**Town of Underhill
Route 15 Sidewalk Feasibility Study**

Final Report

TO: Dave Roberts, CCMPO Senior Transportation Planner
FROM: Amy H. Bell, Bicycle & Pedestrian Coordinator
DATE: February 8, 2007
SUBJECT: Underhill – Rte. 15 Draft Sidewalk Feasibility Study

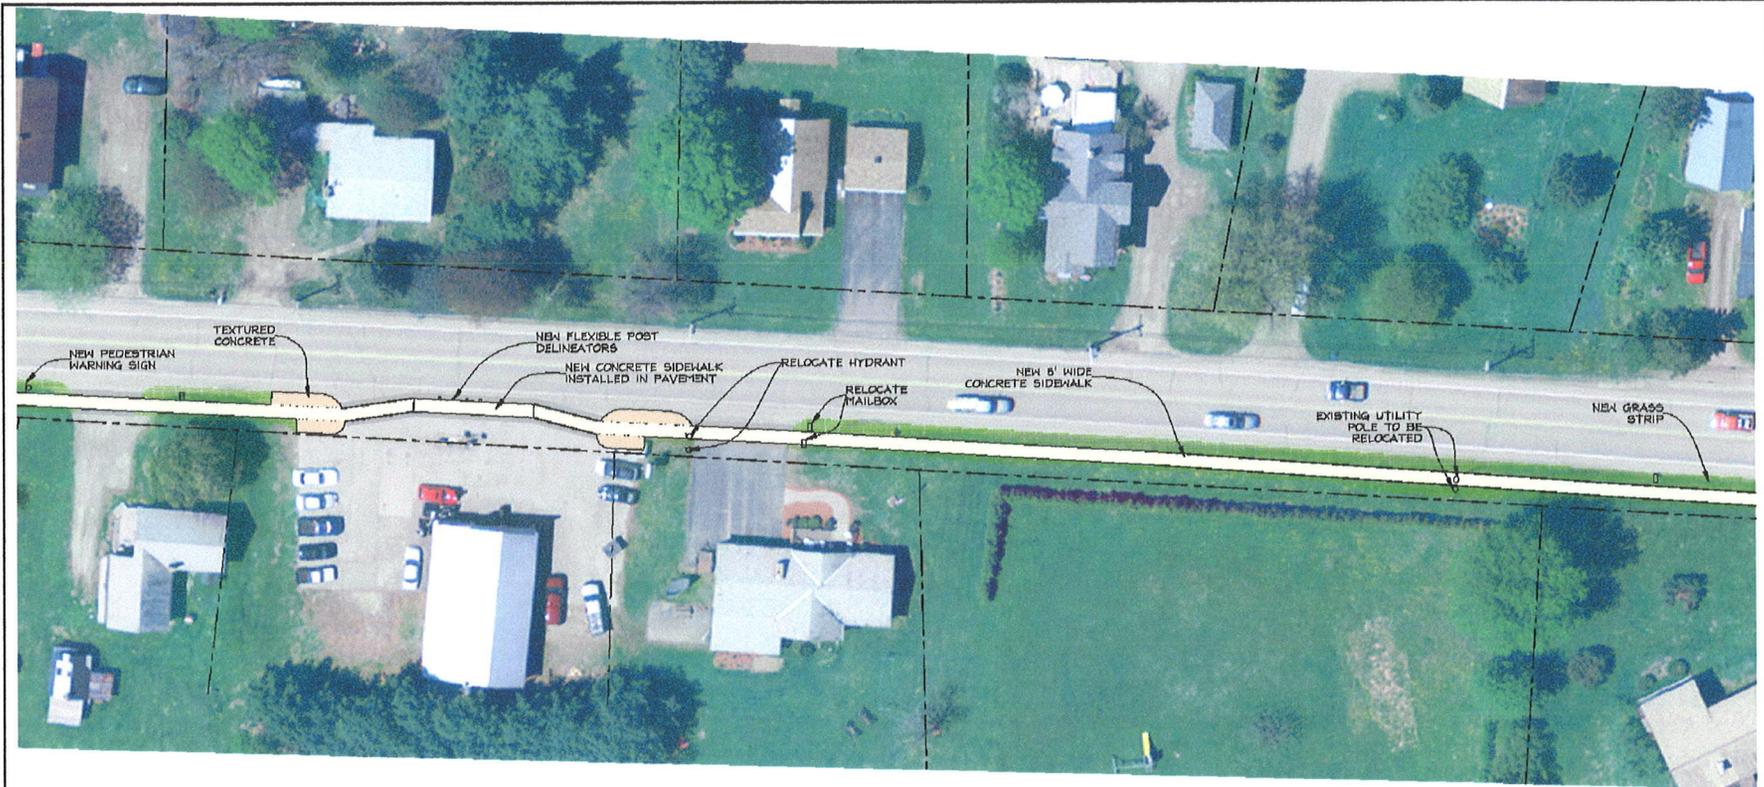
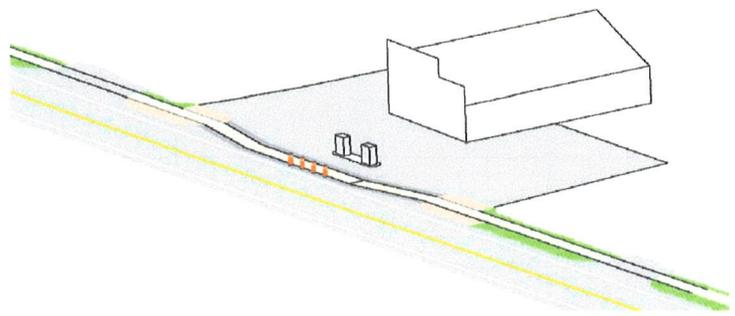
13. Appendix A, Sheet #3 - At the gas station what is the distance from the outside edge of the sidewalk to the white line (fog line)? It would appear as if the sidewalk will reduce the shoulder width significantly in this area. Does the width as proposed meet the VT State Design Standards? If not you may need a design exception to construct the sidewalk as proposed.
